6.0 ADMINISTRATIVE CONTROLS

GGNS General

Figure 6.2.1-1
OFFSITE ORGANIZATION

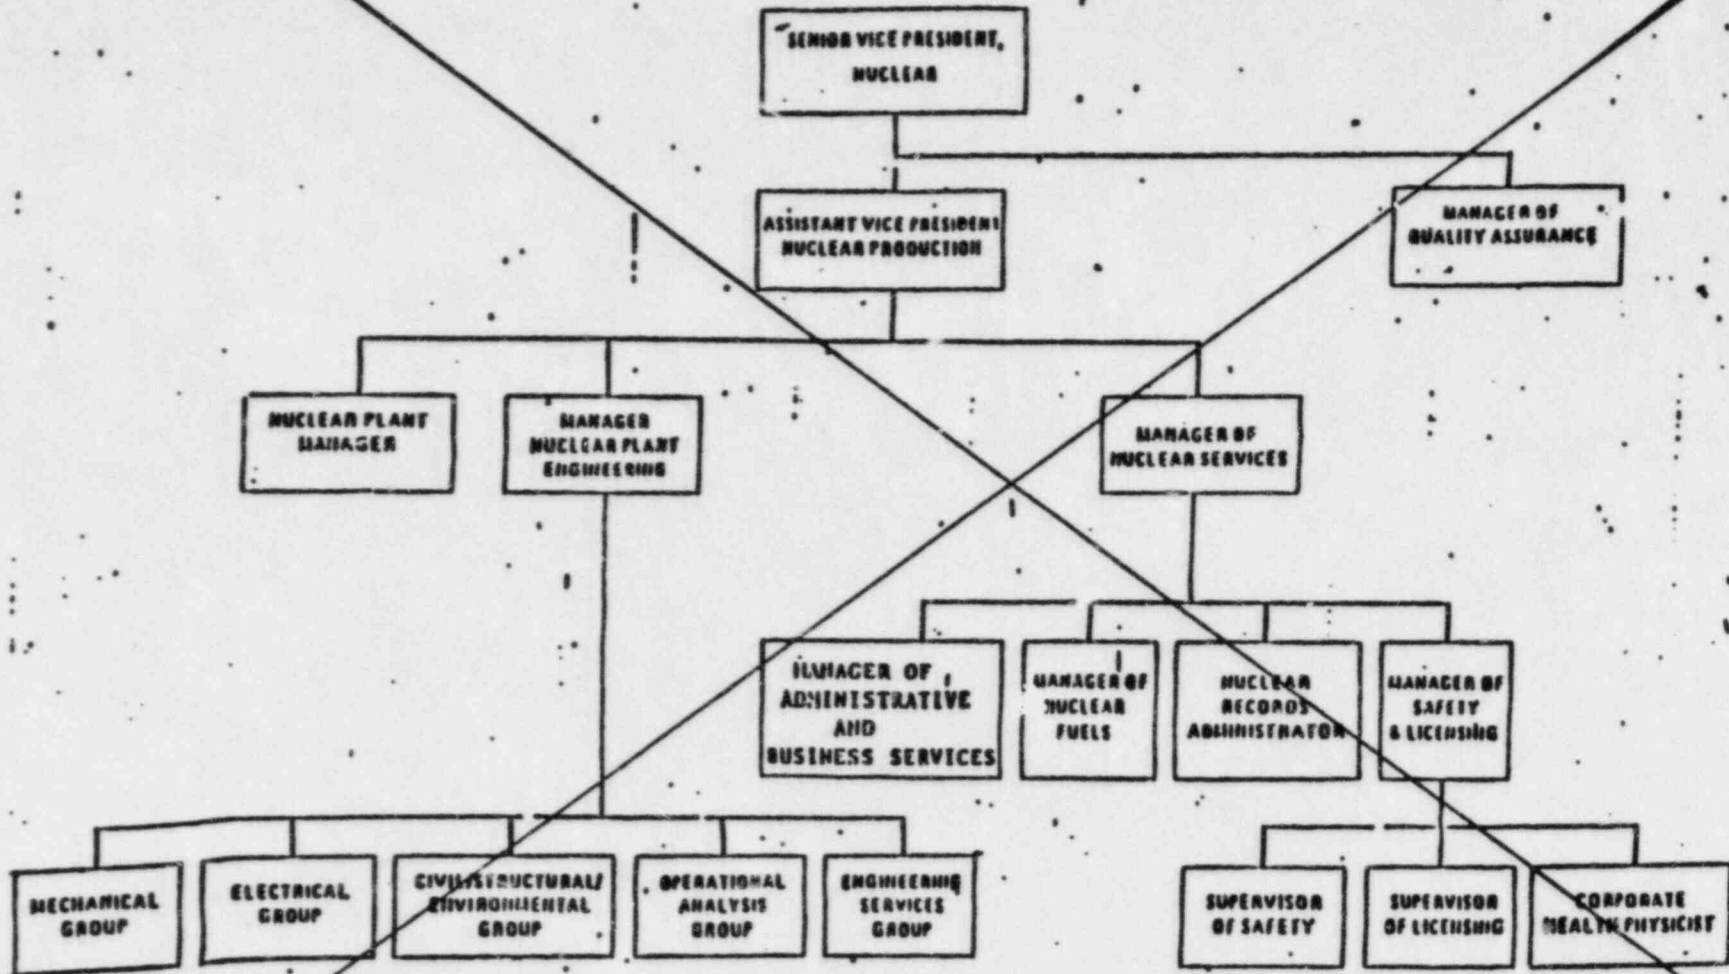
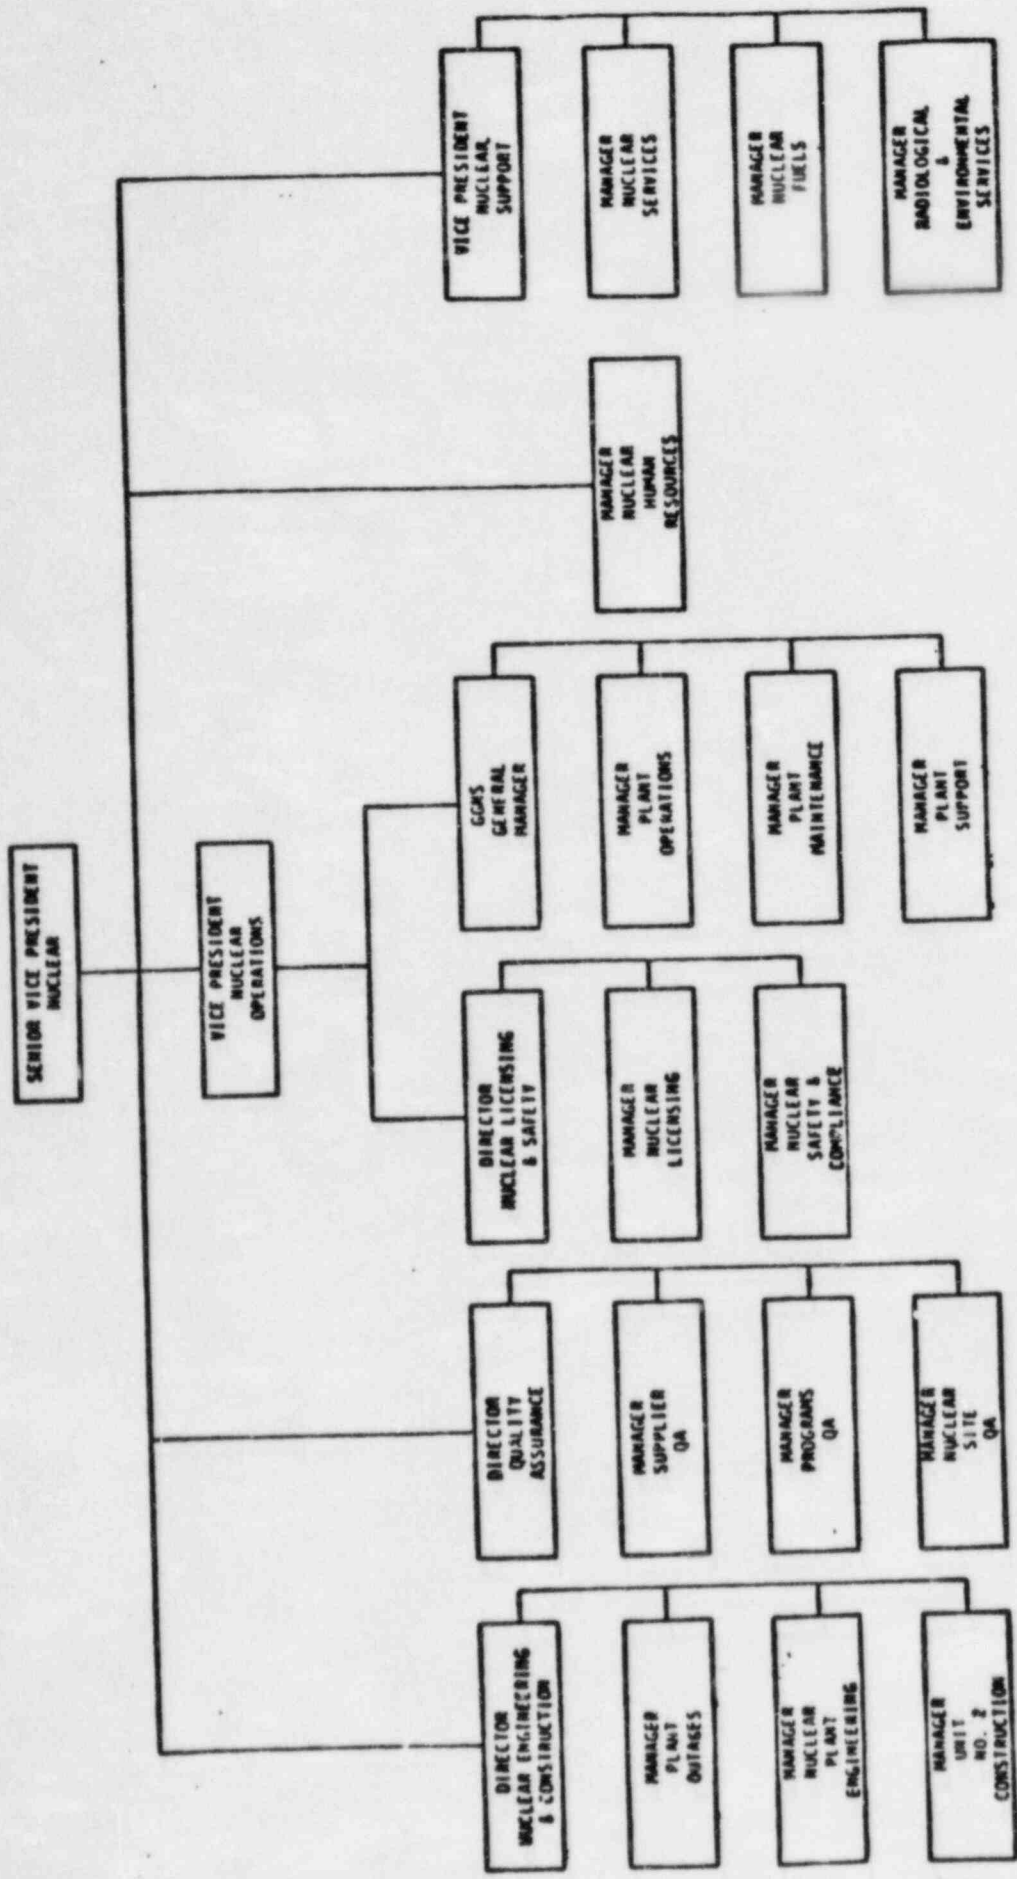
Delete -
Replace with revised figure

Figure 6.2.2-1
 UNIT ORGANIZATION

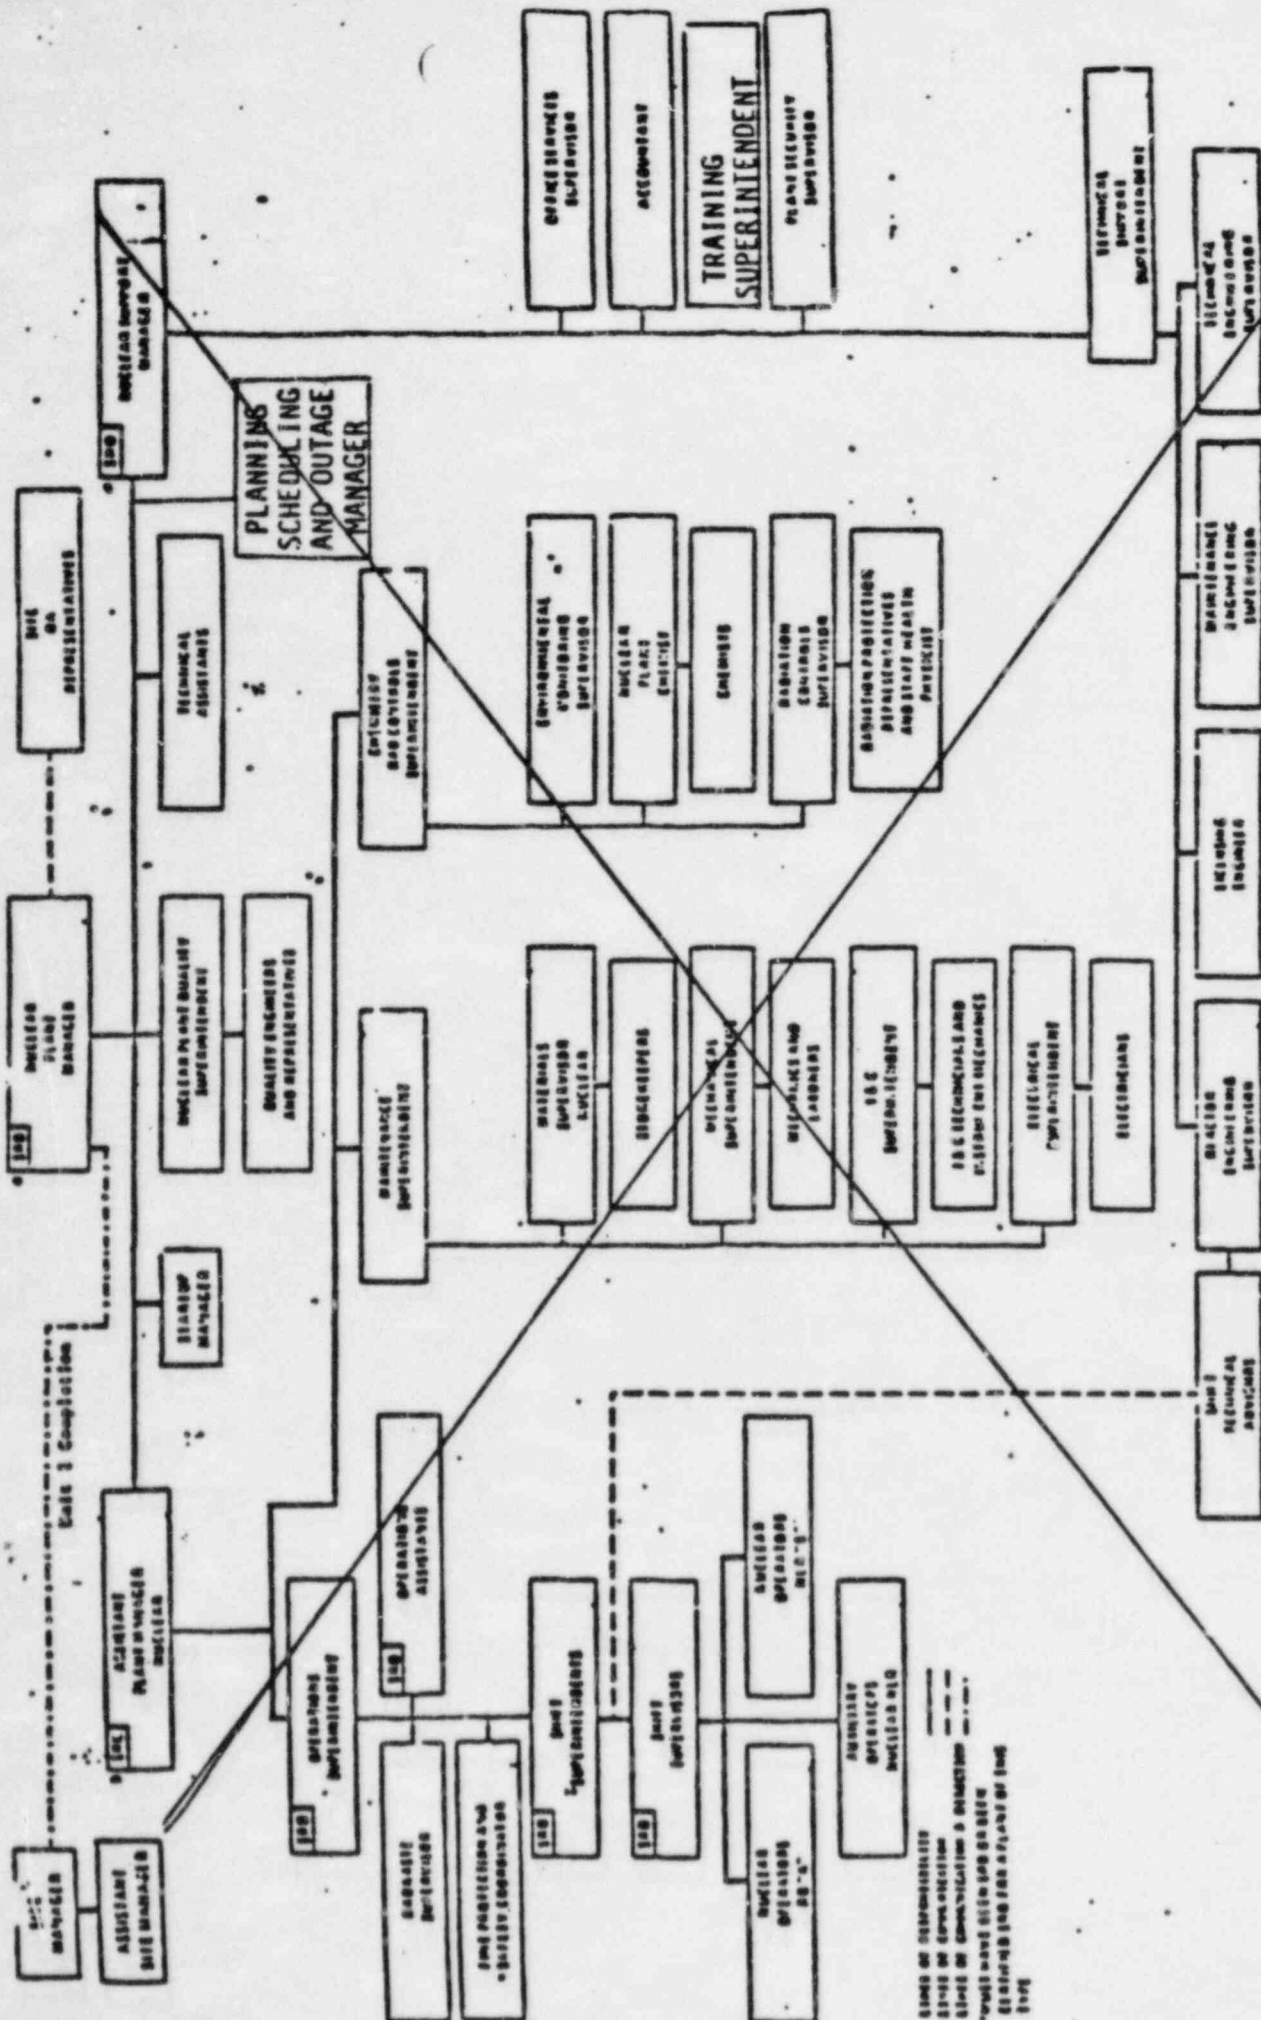
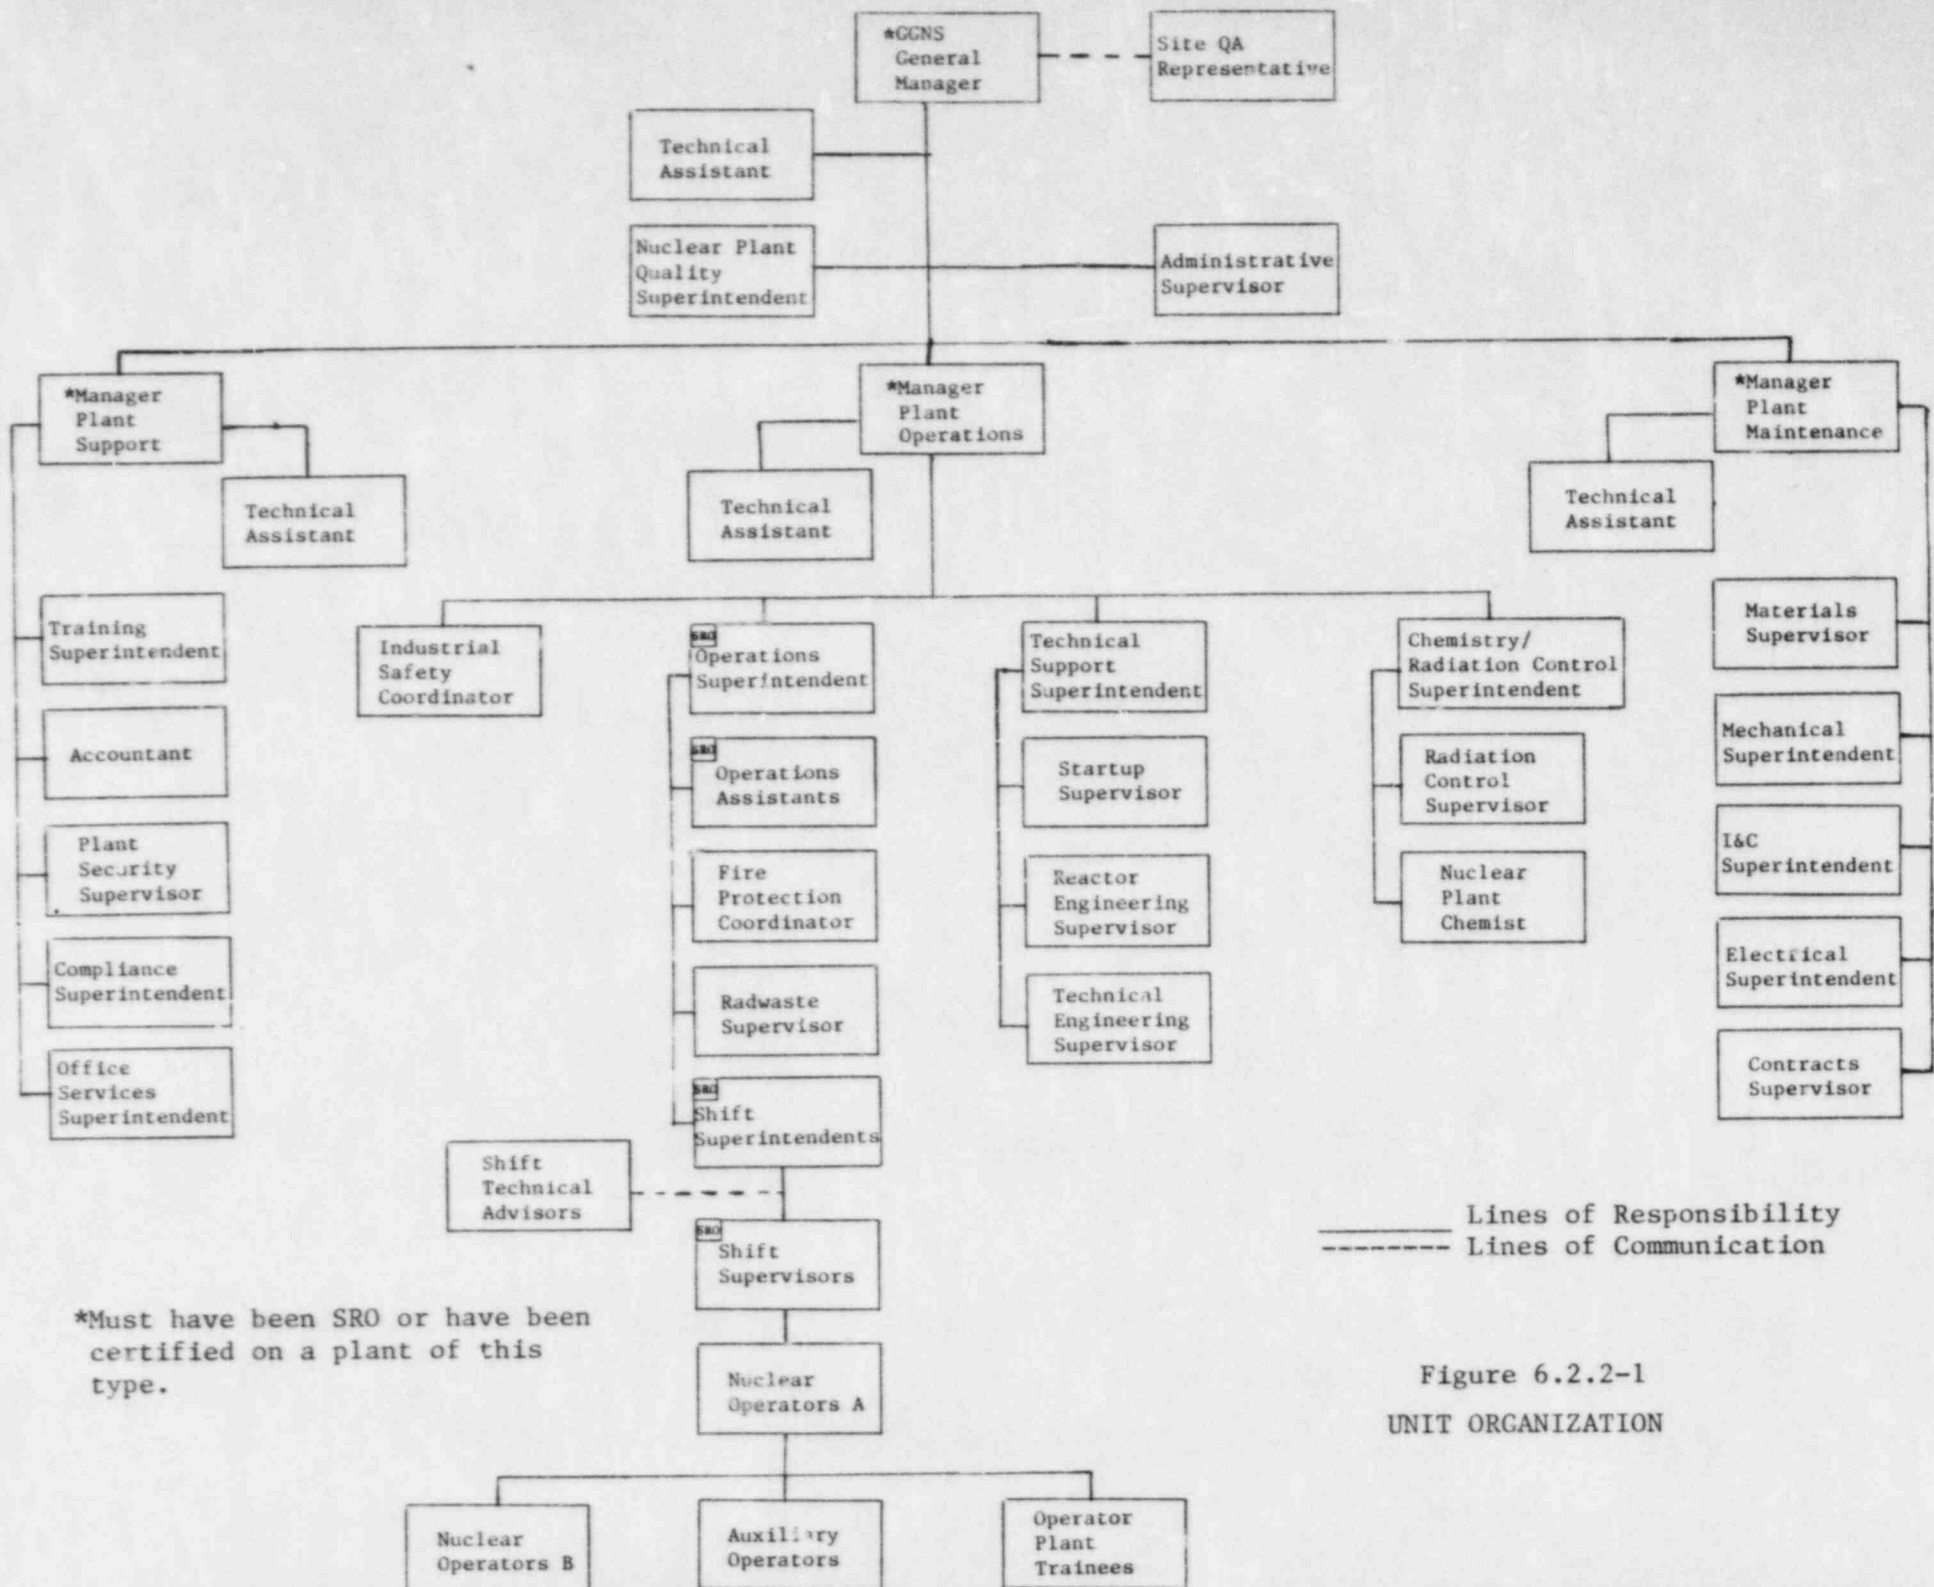
Delete -
 Replace with revised figure
